**TO:** Development Review Board  
**FROM:** Scott Gustin   
**DATE:** May 6, 2014  
**RE:** 12-1138PD Amendment; 70 Appletree Point Lane

**Request:** Amend final plat approval to include minor site utility revisions, adjustment of farmhouse location on lot 20, retention & residing of existing storage shed, and provision of four standard house designs.

Re: Staniford Farms, 70 Appletree Point Lane  
Final Plat Amendment

**C3.2**

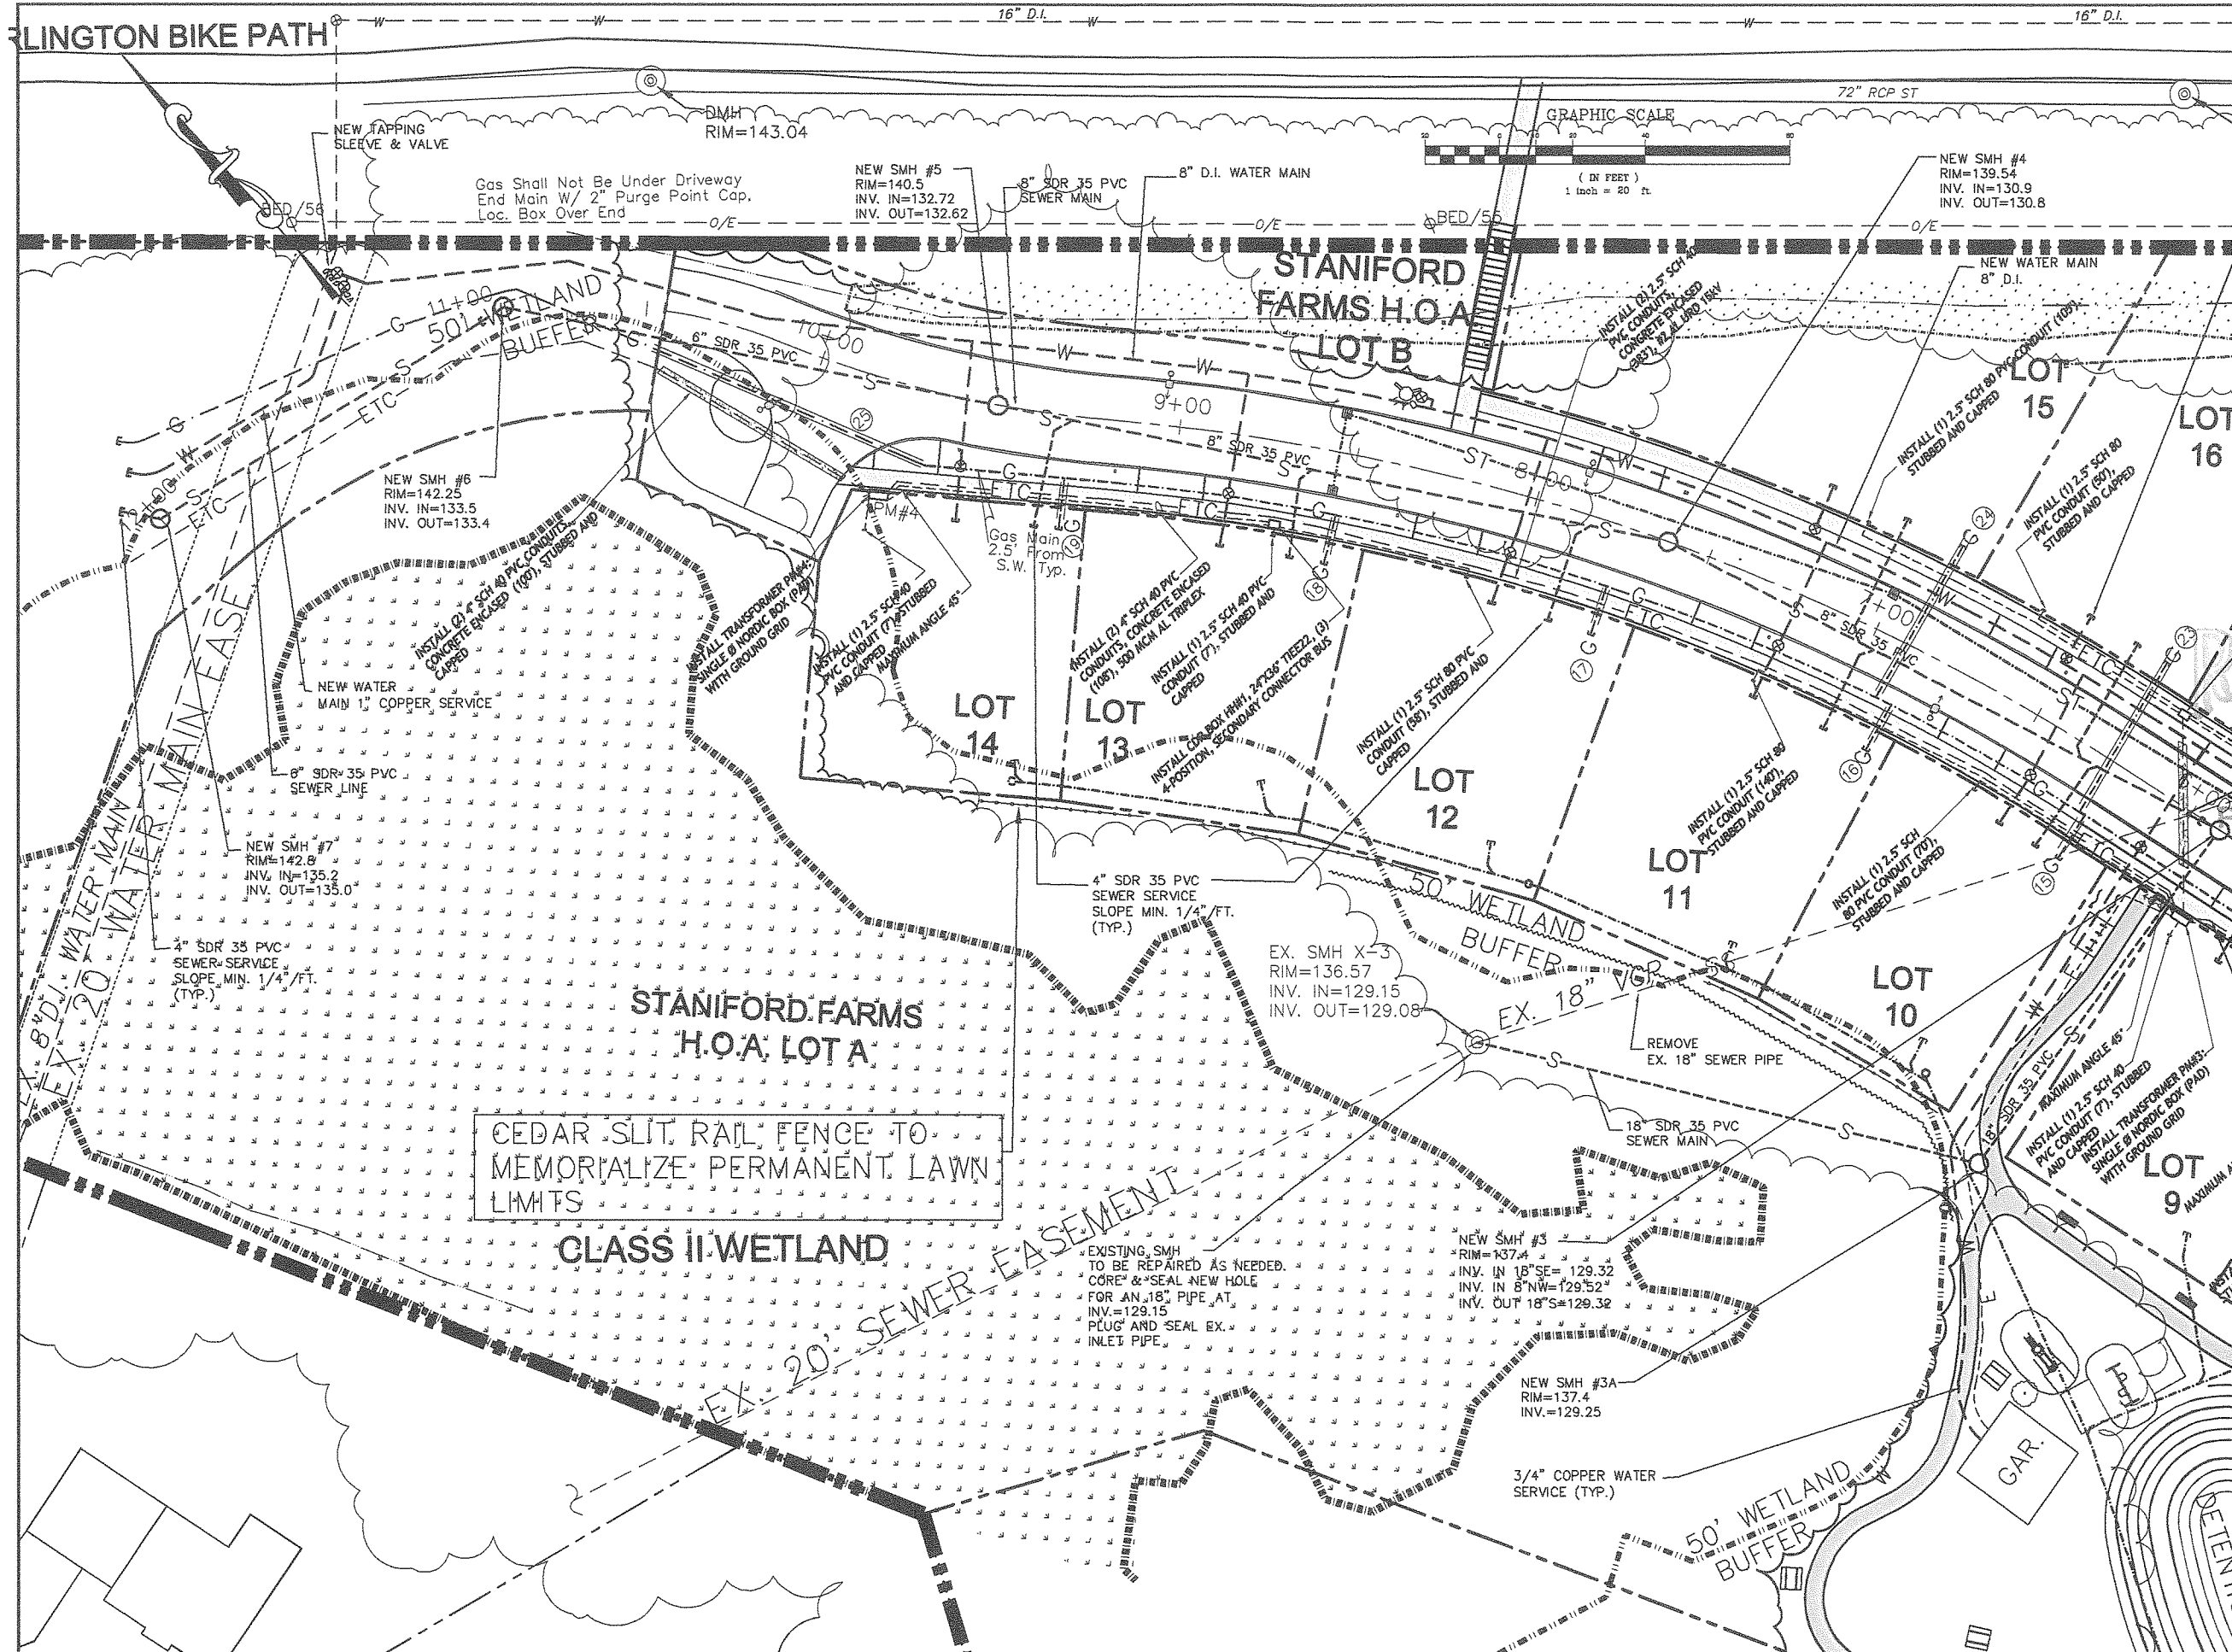
Project infrastructure remains largely unchanged except that utility lines will be laid out to provide greater separation distances than originally proposed. **(Affirmative finding)**

- Minor revisions to the site utilities layout: to provide for greater separation distances between utilities per the request of the utility companies.
- Moved the relocated Farmhouse: on Lot 20 by 20' to the west to gain better separation distance from the existing tree line (canopy) on the east side of the house.
